DEVELOPMENT REVIEW COMMITTEE (DRC) COMMENT REPORT

PROJECT NAME: Flagler Residences

CASE NUMBER: UDP-S21059

Site Plan Level II Review: 320 Multifamily Residential

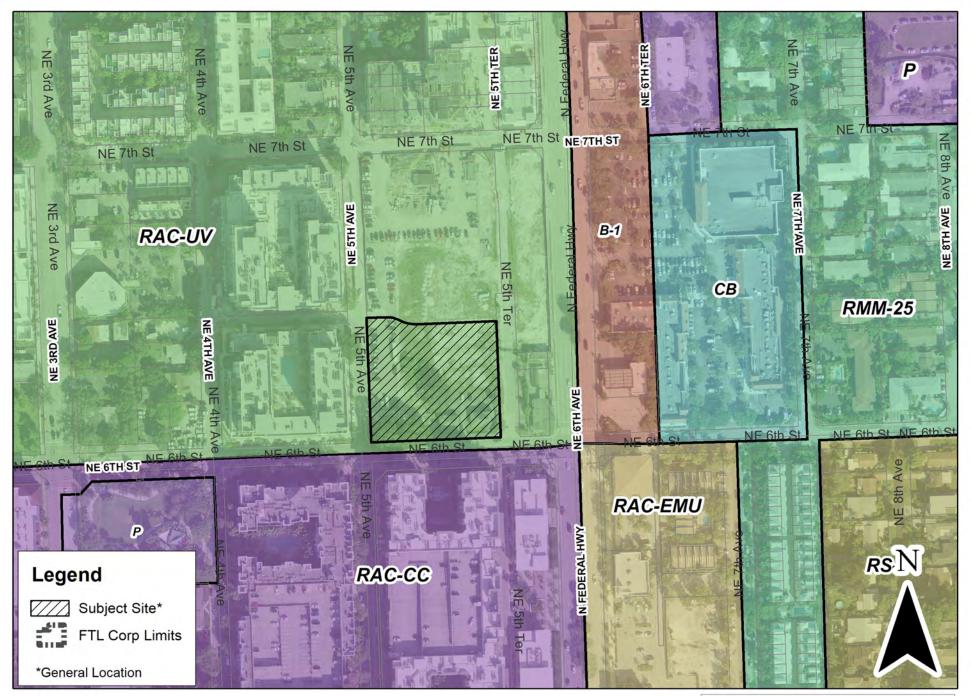
Q7	Creative Façade Composition: Encourage a rich layering of architectural elements throughout the building, with special attention to facades below the shoulder level.	Х			
Q8	Original, Self-Confident Design: Encourage a range of architectural styles that each create a strong identity, strive for the highest quality expression of its chosen architectural vocabulary.	Х			
STOREFRONTS		YES	NO	N/A	MORE INFORMATION NEEDED
SF1	Retail Location Strategy: Encourage ground floor retail in preferred locations.	Х			
SF2	Encourage a combination of storefront styles and types in adjacent buildings, or within single buildings, to create variety and visual interest at the street level.	Χ			
SF3	Encourage durable materials for ground floor retail and cultural uses.	Х			
SF4	Encourage 15 foot minimum floor-to-floor height and encourage interior ground floor flush with adjacent public sidewalk.	Х			Increase floor to ceiling height

SF5	Encourage significant glass coverage for transparency and views. Encourage restaurants to provide clear visual and physical connections to outdoor seating.	Х			
SF6	Encourage pedestrian shading devices of various types (min 5 foot depth).				More details
SF7	Encourage multi-level storefront displays to disguise unfriendly uses or blank walls			Х	
SF8	Encourage well-designed night lighting solutions				Need nighttime renderings
